**SYDNEY INTERNATIONAL CONVENTION,
EXHIBITION AND ENTERTAINMENT PRECINCT
(SICEEP)**

DARLING SQUARE SOUTH-EAST PLOT

ACCESS REPORT

**FOR STAGE 2 STATE SIGNIFICANT
DEVELOPMENT APPLICATION (SSDA 9)**

6.3. SE1 – 1 Bedroom Type Unit Design (L02)

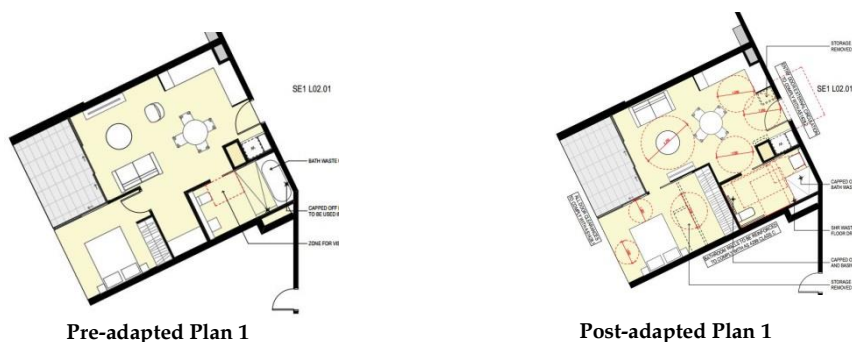
From the entry doorway into the 1 bedroom type adaptable unit in tower SE1, accessible paths of travel to the various areas of the unit such as the main bathroom, kitchen, laundry, living and dining, and the main bedroom can be readily achieved in accordance with AS4299. Also the main bathroom achieves an overall dimension of 2m width by 3.7m length to sufficiently accommodate all the required circulation spaces around the toilet pan, wash basin and shower recess in accordance with AS1428.1 – 2009.

The overall layout of the main bedroom achieves compliance with AS4299 and allocation of furniture items such as the television set outside this bedroom entry can be finalised during design development stage.

- (i) Ensure the sliding doorway leading into the main bathroom achieves a clear opening width of at least 850mm to be compliant with AS1428.1 – 2009.
- (ii) Ensure the main bathroom at pre-adaptation stage is provided with continuous water-proofing and tiling, under the bath tub. This is to ensure that the process of adapting that bathroom to comply with AS1428.1(2009) is achievable at minimum cost and effort for the end user, as provided in objects of AS4299.

In addition ensure all the required sanitary fittings and fixtures are installed in accordance with AS1428.1 – 2009.

- (iii) Ensure all door components comply with AS1428.1 – 2009.
- (iv) Provide continuous wheel chair access to balconies at pre-adapted stage or if not accessible from outset at pre-adapted stage, provide a set-down slab down to allow for use of removable ramp, compliant with AS1428.1 – 2009.

Alternatively the height of balcony balustrade to be increased from outset to allow for a raised external floor surface level with internal area to be installed (at post-adaption) and still satisfy BCA balustrade height requirements.

- (v) Provide slip resistant floor surface with min. wet pendulum test rating of 'P3' (under HB198/AS4586) in all wet areas such as bathroom, kitchen and laundry as required under AS4299.

6.5. SE1 – 2 Bedroom Type Unit Design (L02 - 06)

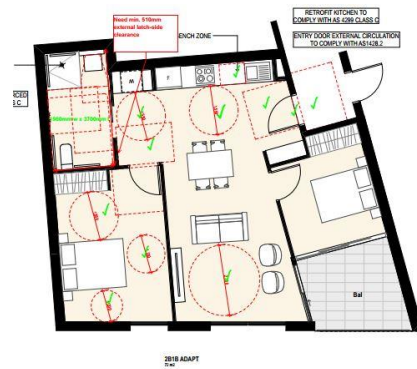
From the entry doorway into the 2 bedroom type adaptable unit in tower SE1, accessible paths of travel to the various areas of the unit such as the main bathroom, kitchen, laundry, living and dining, and the main bedroom can be readily achieved in accordance with AS4299. However, at the current stage there is no provision of a laundry area along an accessible path of travel. The laundry area to be detailed in design development stages to be compliant with AS4299.

- (i) Provide a doorway with 850mm clear open width (generally 920mm leaf) for the entry leading into the main bedroom at pre-adapted stage, compliant with AS1428.1 – 2009 as required under AS4299.
- (ii) Provide a laundry area along an accessible path of travel from the main unit entry doorway which can accommodate a 1550mm clear diameter turning circle in front of laundry appliances to be compliant with AS4299.
- (iii) Ensure the sliding doorway leading into the main bathroom achieves at least 850mm clear opening width at pre-adapted stage, compliant with AS1428.1 – 2009 as required under AS4299.
- (iv) Ensure the main bathroom at pre-adaptation stage is provided with continuous water-proofing and tiling, under the bath tub.

This is to ensure that the process of adapting that bathroom to comply with AS1428.1(2009) is achievable at minimum cost and effort for the end user, as provided in objects of AS4299.

- (v) Provide continuous wheel chair access to balconies at pre-adapted stage or if not accessible from outset at pre-adapted stage, provide a set-down slab down to allow for use of removable ramp, compliant with AS1428.1 – 2009.

Alternatively the height of balcony balustrade to be increased from outset to allow for a raised external floor surface level with internal area to be installed (at post-adaptation) and still satisfy BCA balustrade height requirements.

- (vi) Provide slip resistant floor surface with min. wet pendulum test rating of 'P3' (under HB198/AS4586) in all wet areas such as bathroom, kitchen and laundry as required under AS4299.
